DOCUMENT 009113.1 – ADDENDUM #2

- A. Project Name: BPCPC Mechanical Systems Modifications
- B. Owner: Battery Park City Authority
- C. Engineer: OLA Consulting Engineers
- D. Engineer Project Number: NBPC0002.00
- E. Date of Addendum: 6/26/14

- A. This Addendum includes the following attached Documents and Specification Sections:
 - 1. Section 095429 – Wood Panel Ceilings dated 6/12/14, (new).
- B. This Addendum includes the following attached Sheets:
 - 1. Architectural Sheets A-001.00 , A-101.00, A-500.00, dated 6/12/14, (new).
 - a. Addendum 2 scope includes replacement of the drop ceiling on the 4th floor per the attached drawings and specification.

FOURTH FLOOR REFLECTED CEILING PLAN
 1/8" = 1'-0"

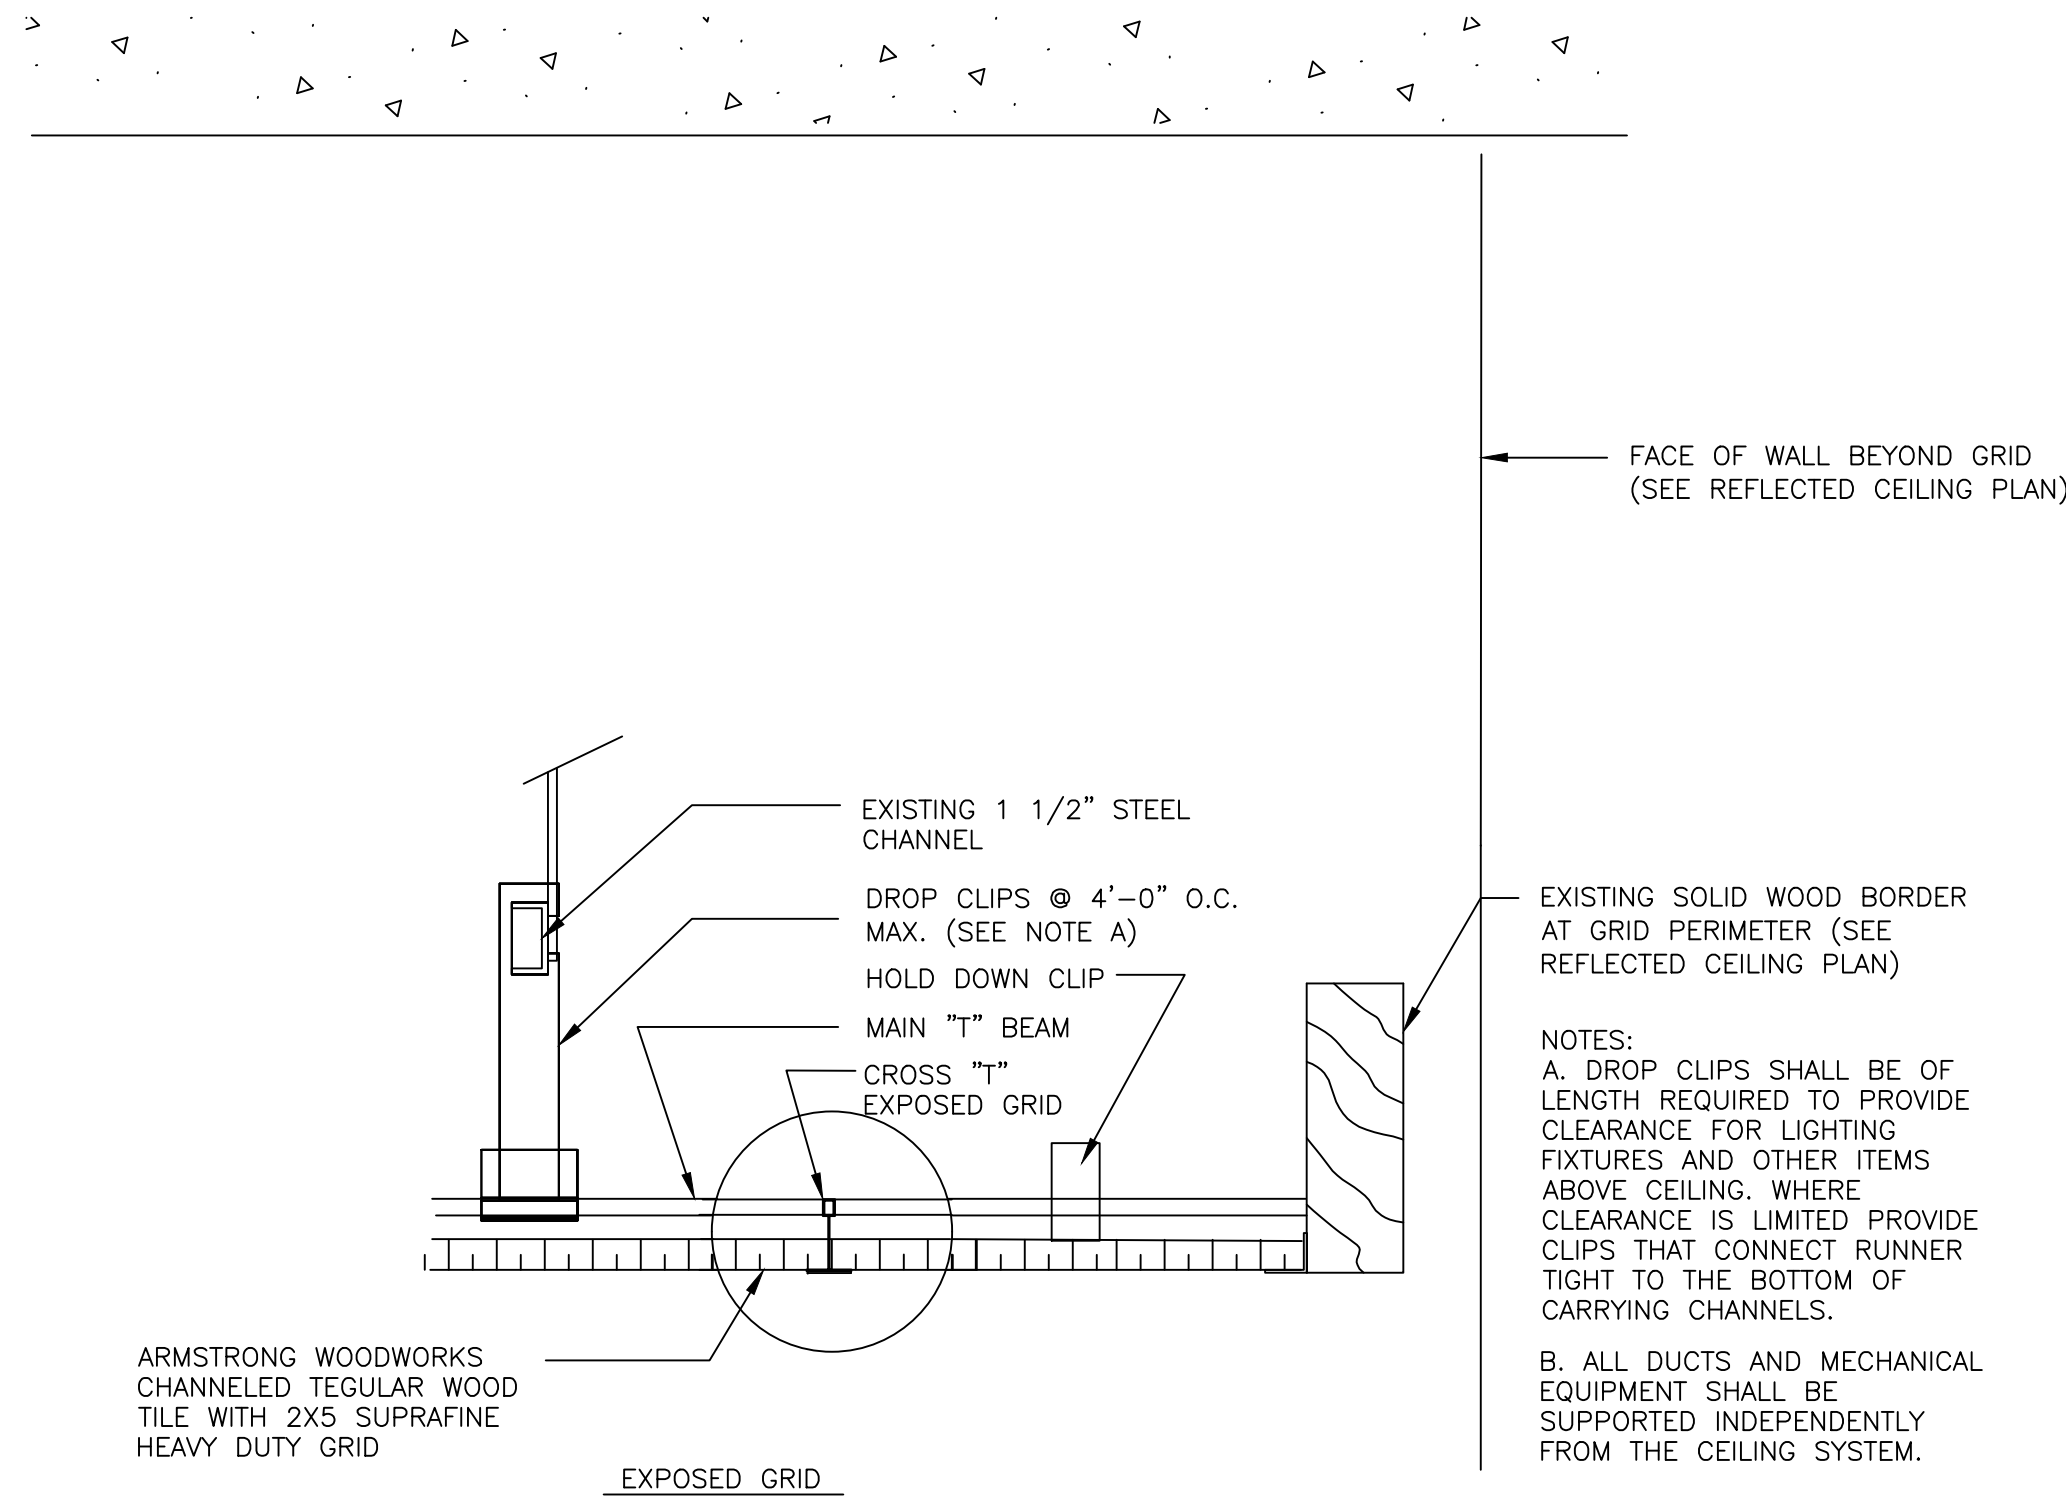
NOTE: THE SCOPE OF WORK IS THE FOURTH FLOOR CORRIDOR GRIDDED AREA ONLY. SEE DEMOLITION AND NEW CONSTRUCTION NOTES ON PREVIOUS SHEET.

1. GRID TO BE INSTALLED WITHIN AND ATTACHED TO THE EXISTING TILE AND GRID SYSTEM; SEE NEW CONSTRUCTION NOTES OF NOTES SHEET.
2. ALL CUTS, OR CUT TILES AT WOOD TILE PERIMETER WHERE GRID TOUCHES BORDER ARE TO BE NON-CHANNELED WOOD TILES PER THE INCLUDED SPECIFICATIONS.
3. CHANNELED TILES ARE TO BE INSTALLED WITH DIRECTION OF CHANNELS AS SHOWN GRAPHICALLY. MAIN AND SECONDARY GRID MEMBERS ARE TO BE INSTALLED TO ACCOMMODATE CHANNEL DIRECTION WITH PROPER SUPPORT. THIS IS TO BE CONFIRMED IN SHOP DRAWING DETAILS AND LAYOUTS.
4. NOT ALL REQUIRED PRETENSIONS AND INSERTED DEVICES AND ACCESSORIES ARE SHOWN GRAPHICALLY ON THE EXISTING CONSTRUCTION NOTES. ALL PRETENSION DEVICES ARE TO BE INSTALLED IN THE SAME LOCATIONS AS IN THE EXISTING REMOVED WOOD TILE CEILING ASSEMBLY.
